Idle Free Systems Update to Harness

Battery Fuse:

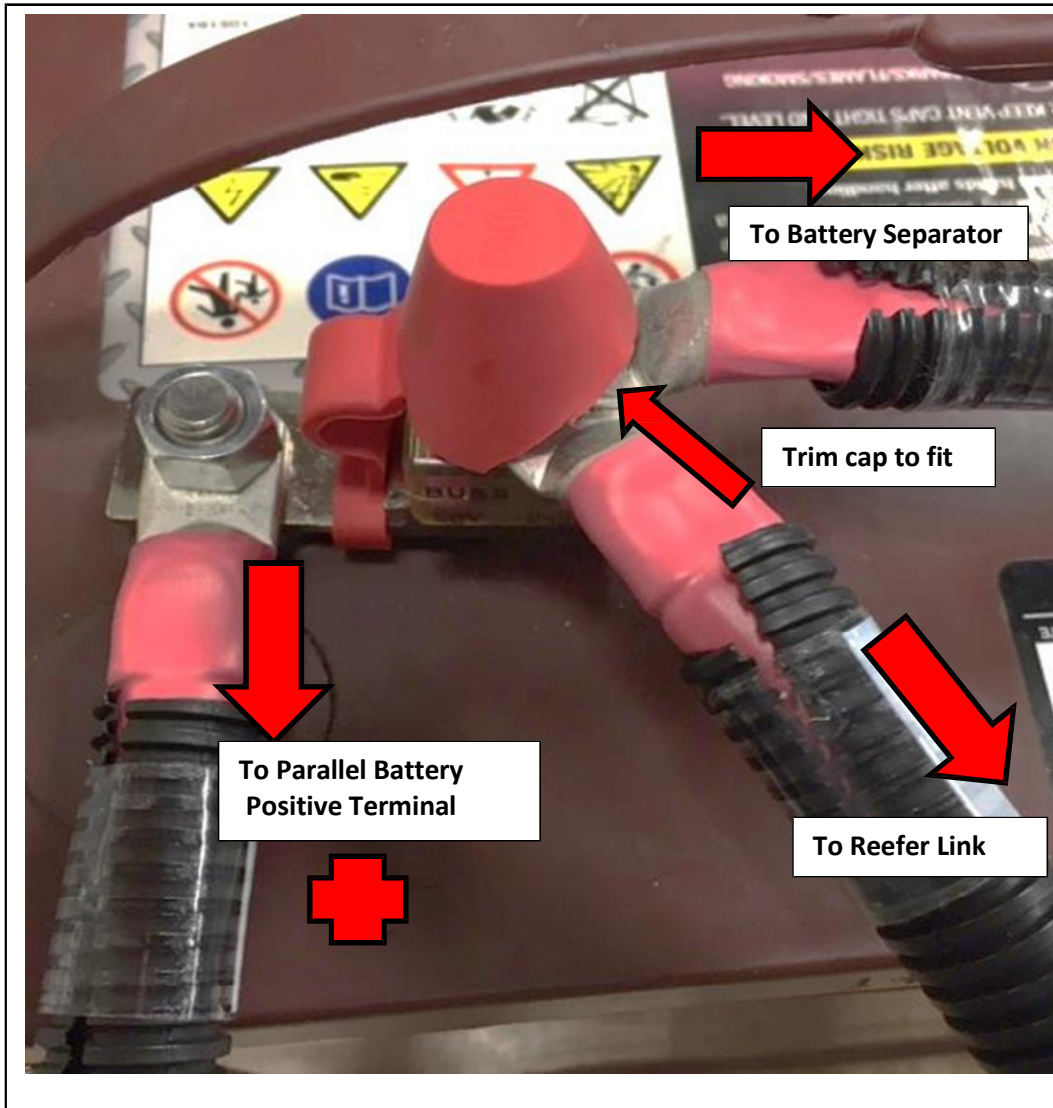
To improve product safety there is a new battery fuse required to be installed between the APU battery bank and the Reefer Link.

Your installation will depend on the battery configuration, please see the suitable instructions below.

1. Remove the battery negative cable. Place the pre-assembled fuse assembly on the positive battery terminal.
2. Place the **Reefer Link** cable on **Top** of the **battery fuse**. (Torque 106 in-lbs.)
3. The parallel battery connection cable should connect directly to the battery terminal on top of the fuse holder tang. (Torque 120-180 in-lbs.)
4. Trim cap cover to fit securely on top of fuse holder stud.
5. Reconnect the battery negative cable.
